# ASHBY USA, LLC

Ref: WPN: 10-3020657.02, 18-2001091.02:schwk  
NOV No. R9-2006-0135

Subject: Required Technical Report

Ashby USA  
Notice of Violation Response  
Photos  
November 28, 2006

Long Valley Wash with Temporary Crossing prior to being removed

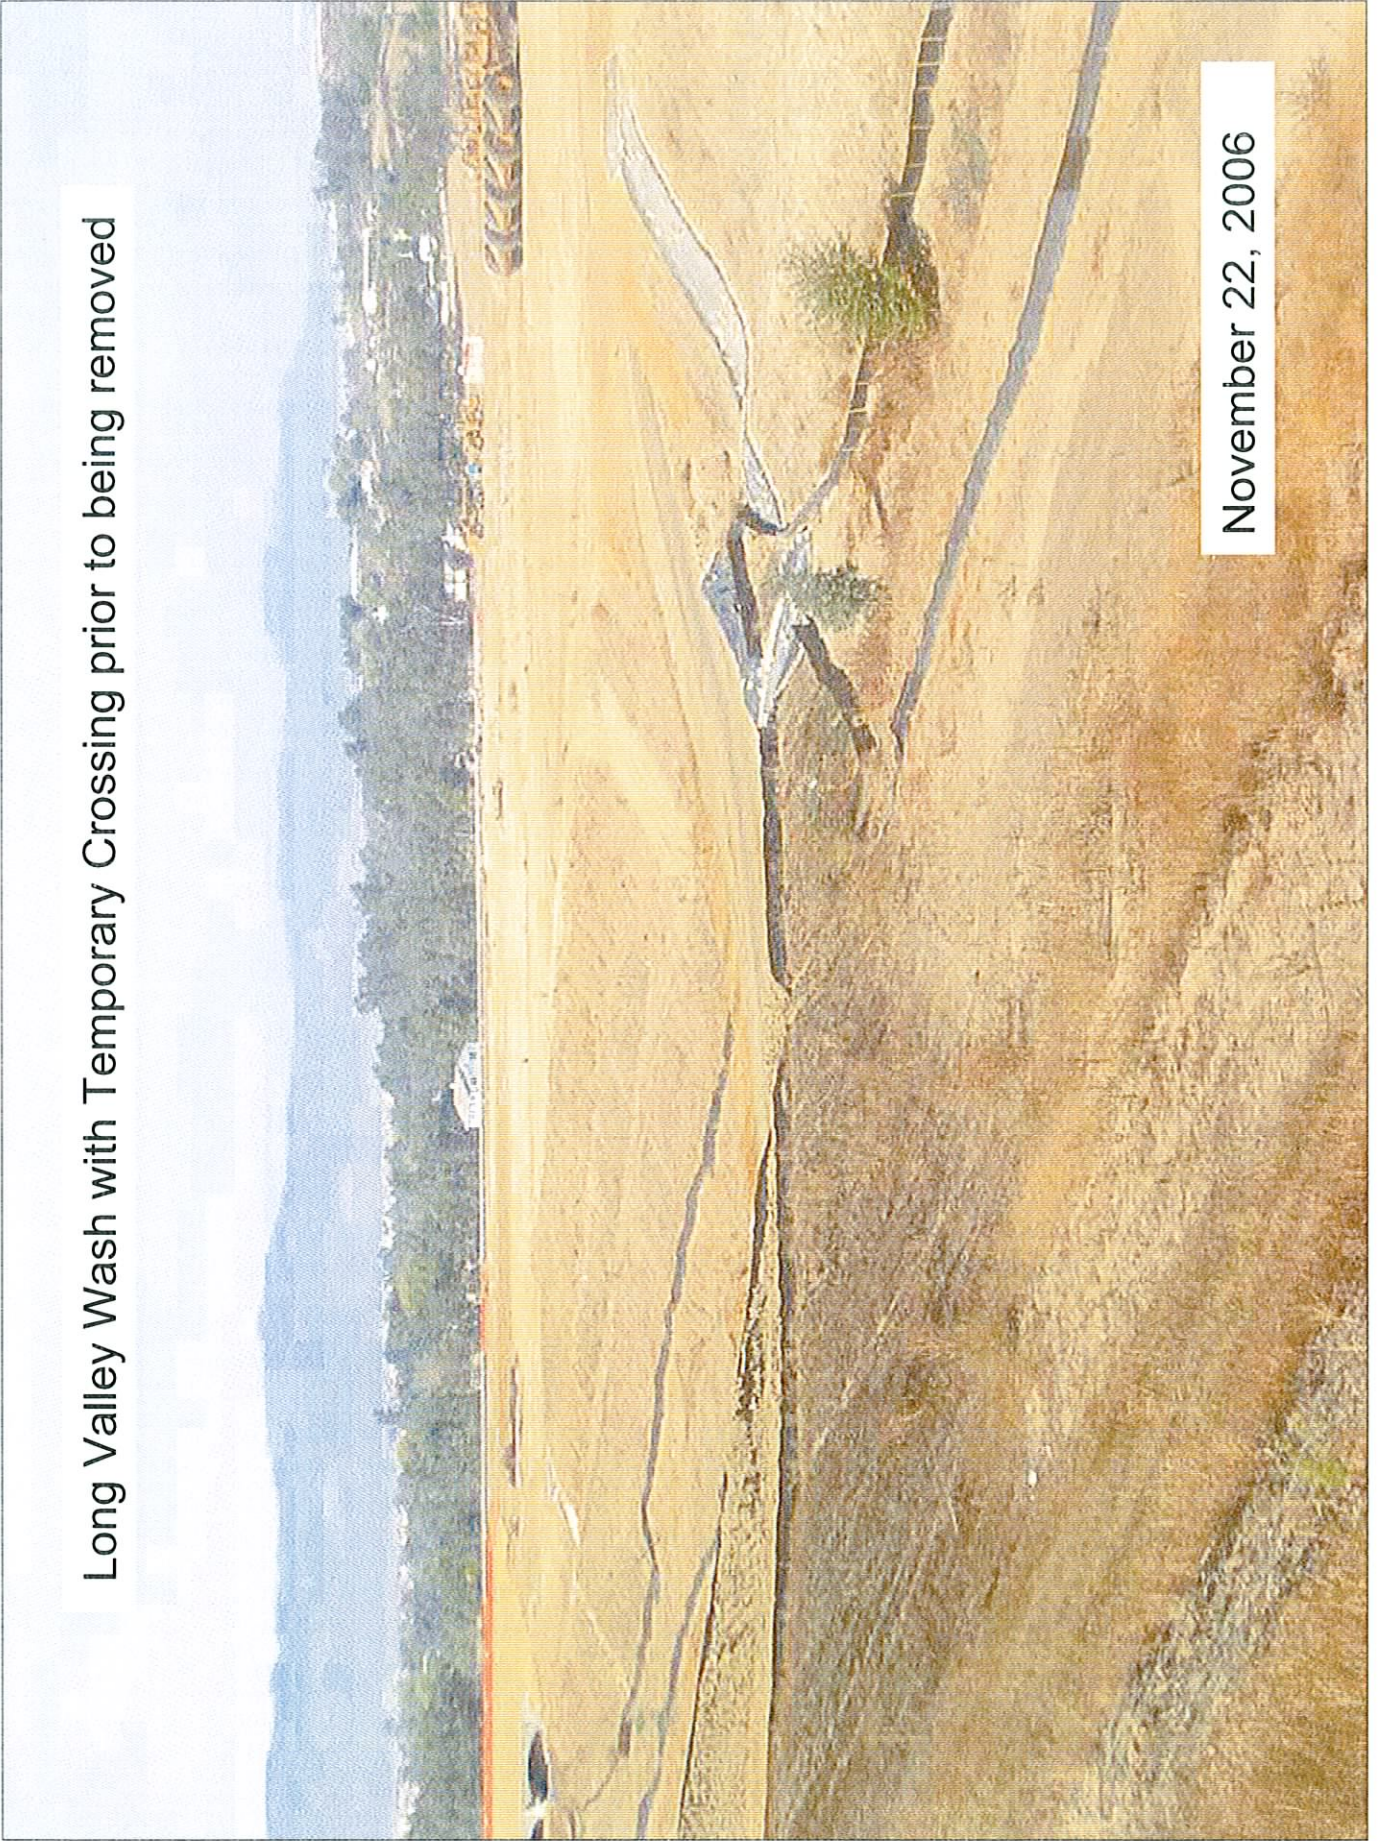
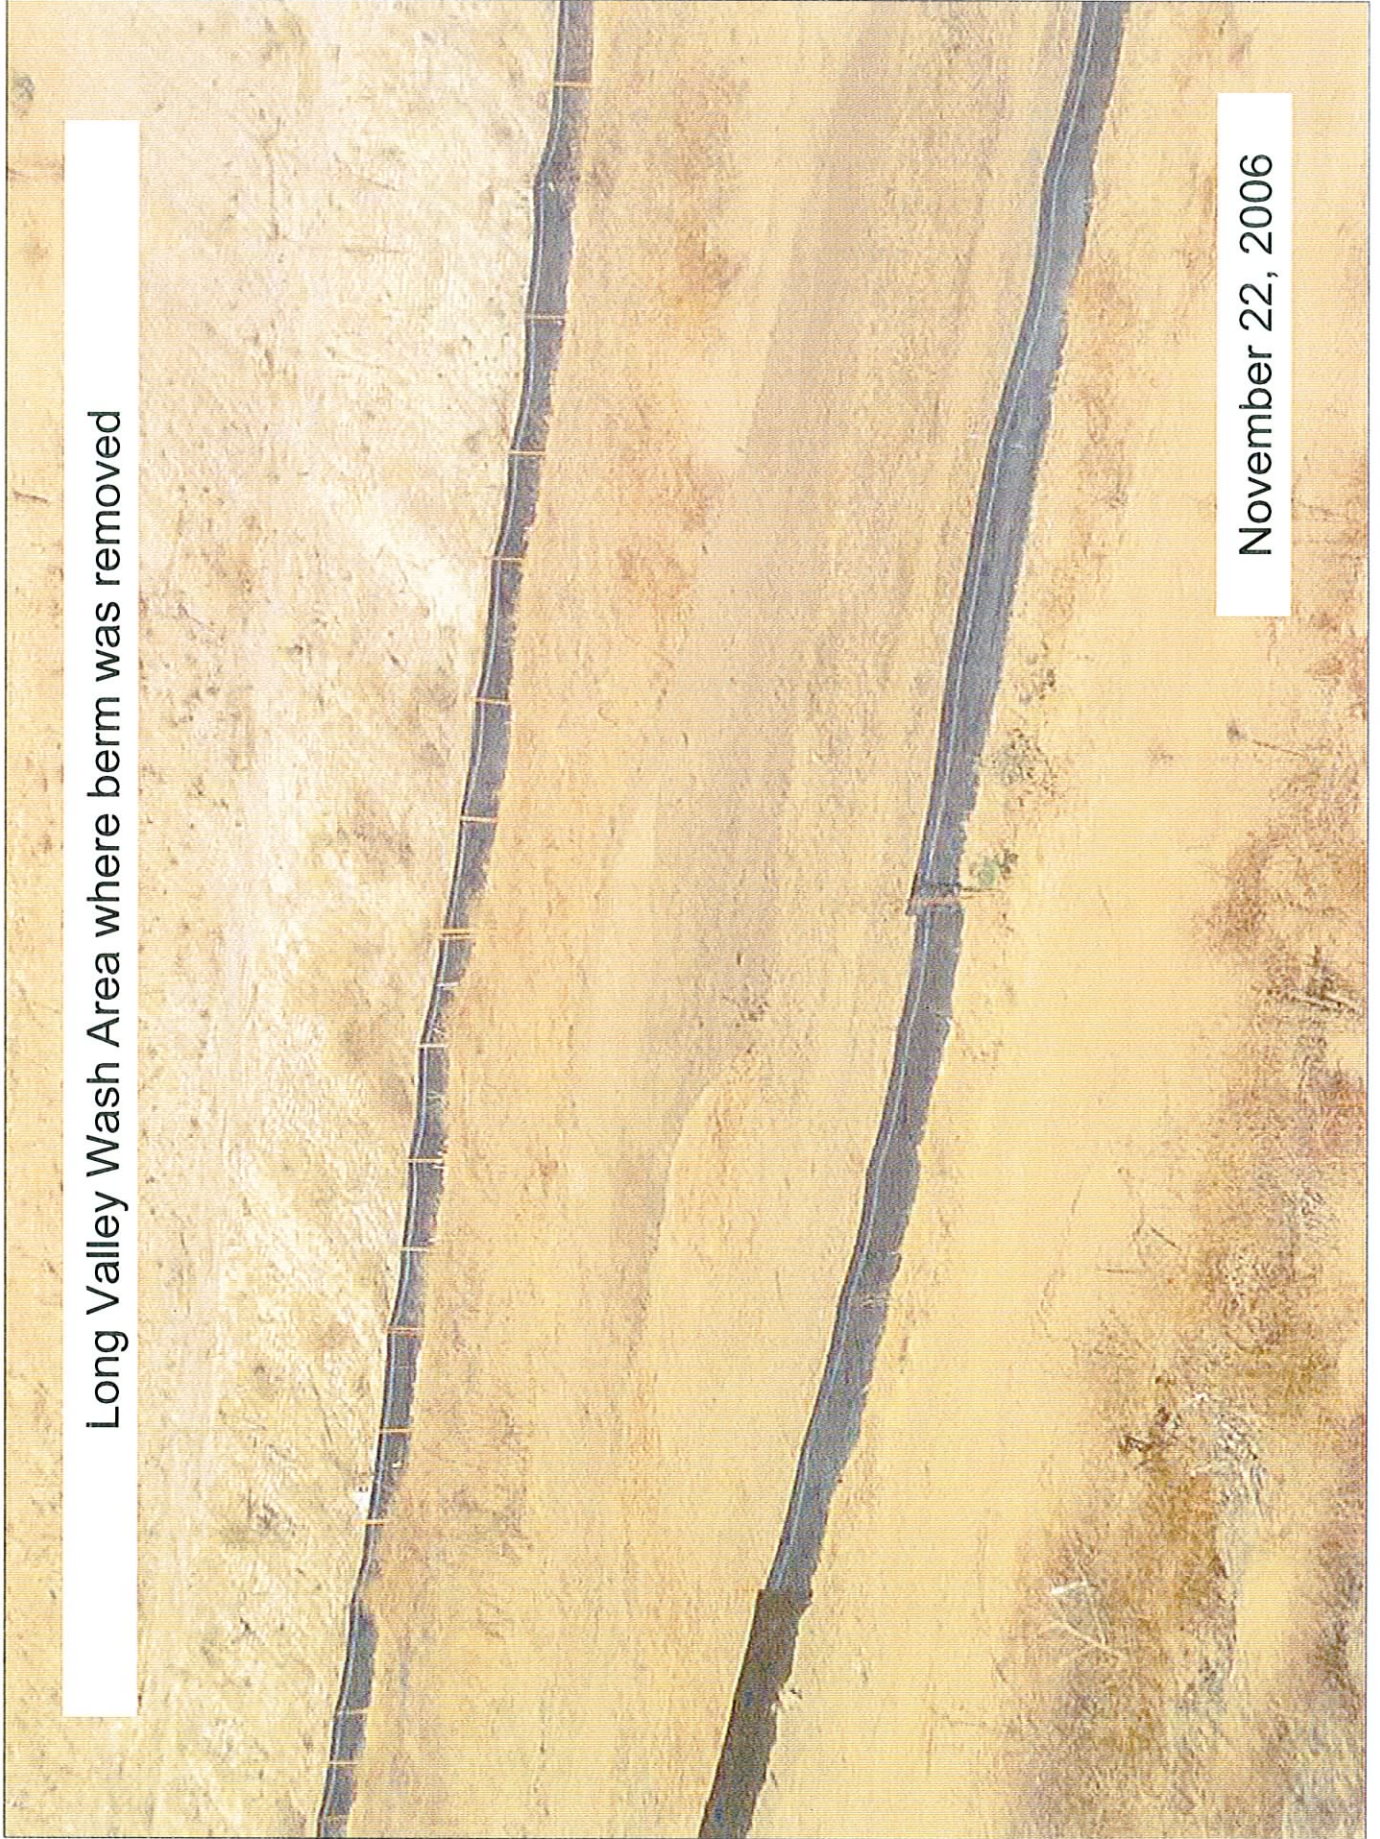
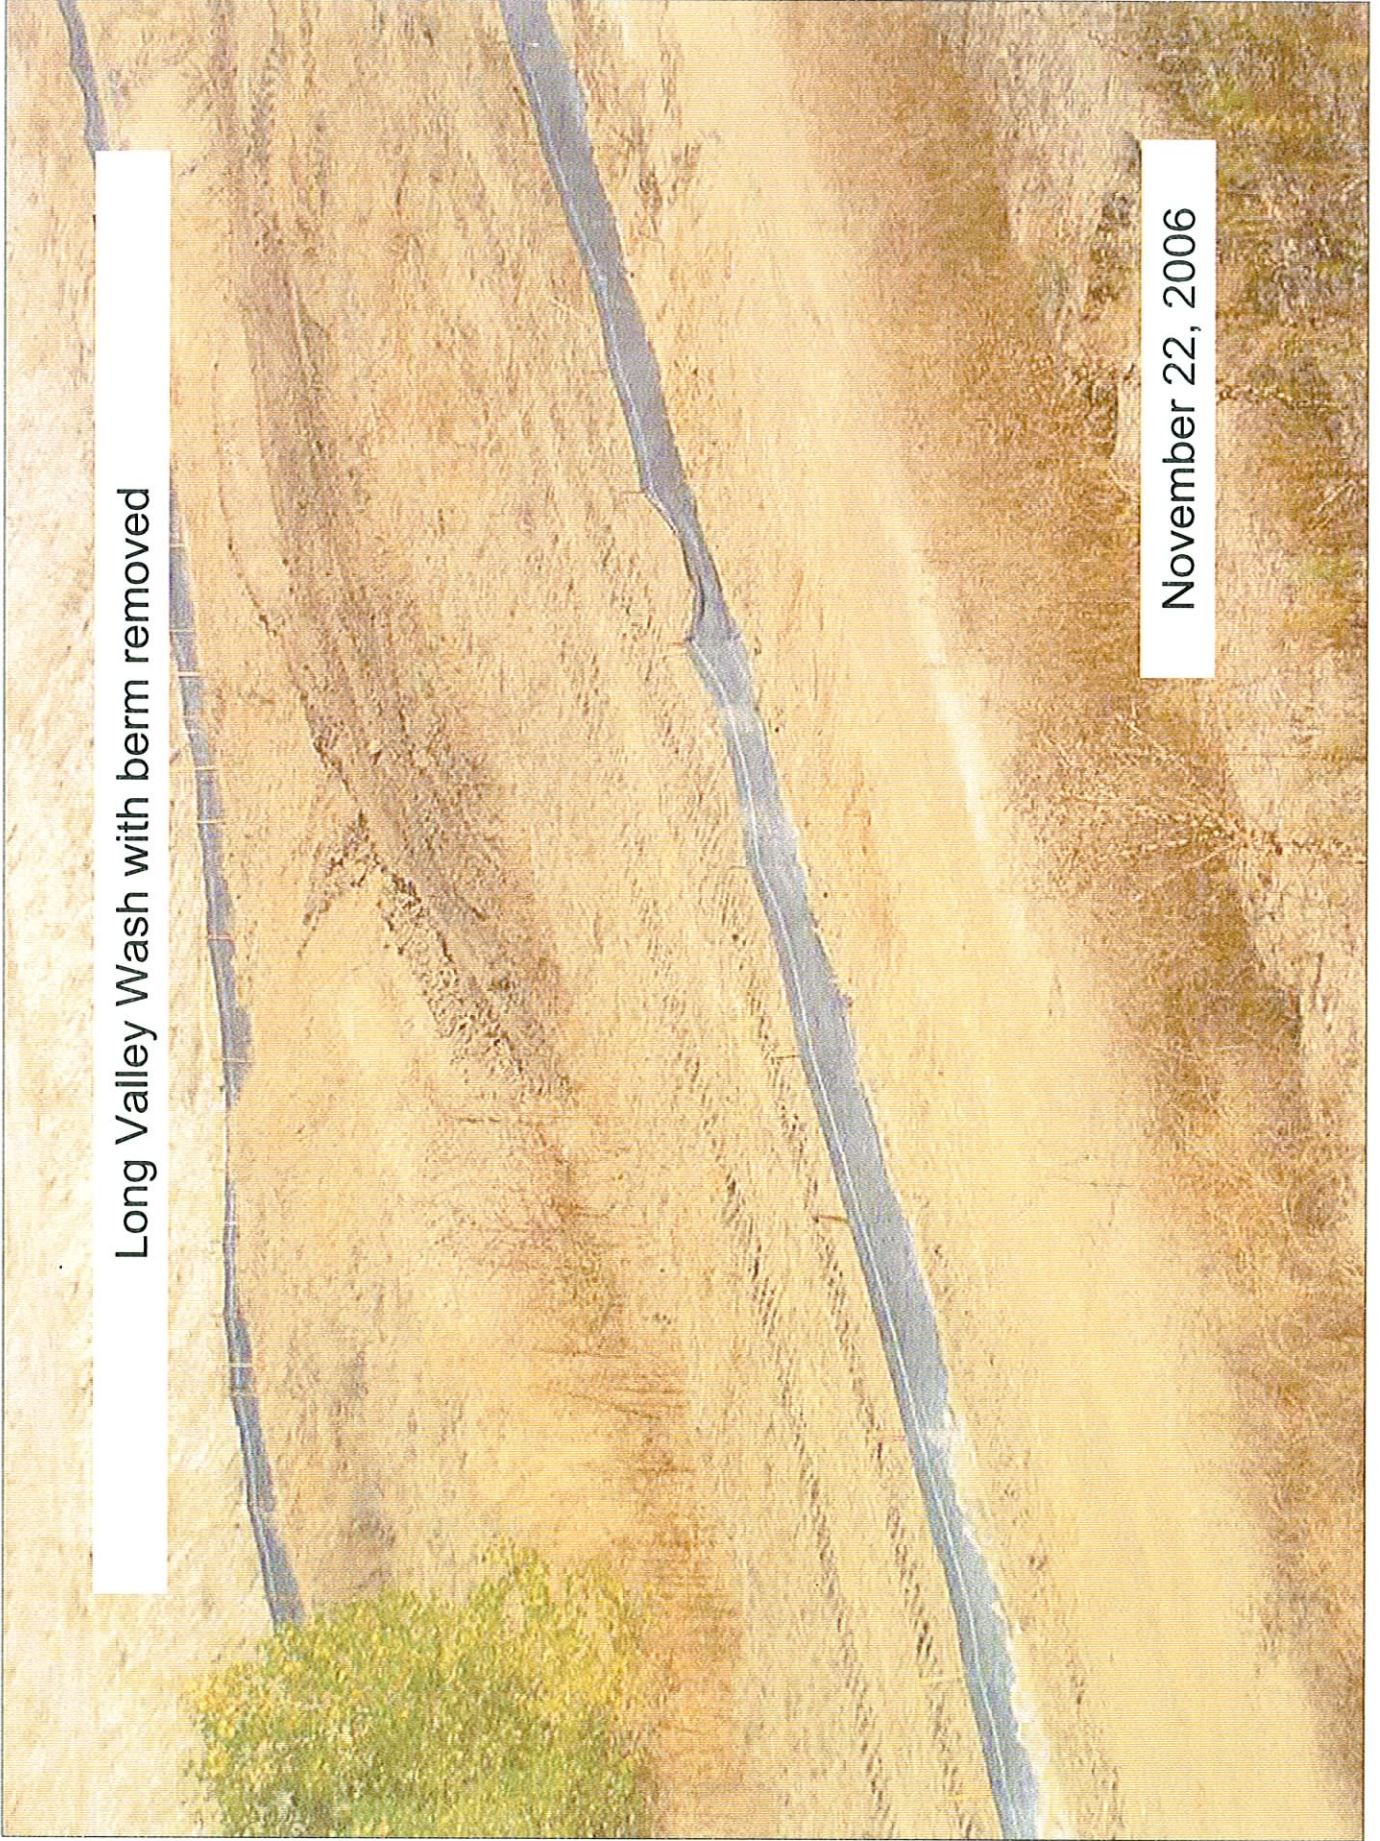
Your site was documented as having disturbed Long Valley Channel Wash from its natural conditions.

Any disturbance to the low flow wash was completed at the direction of the City of Temecula or as approved by the permit and permit modifications. As a result of the site meeting on Wednesday November 15, 2006 with the City of Temecula and CRWQCD, all such disturbances that were not specifically approved by the permit are in the process of being removed and returned to their natural condition and be completed by November 30, 2006 as show on exhibit "A" and sediment traps will only be placed within the permitted areas of impact at the bridge crossings to prevent any sediment discharge from the site.
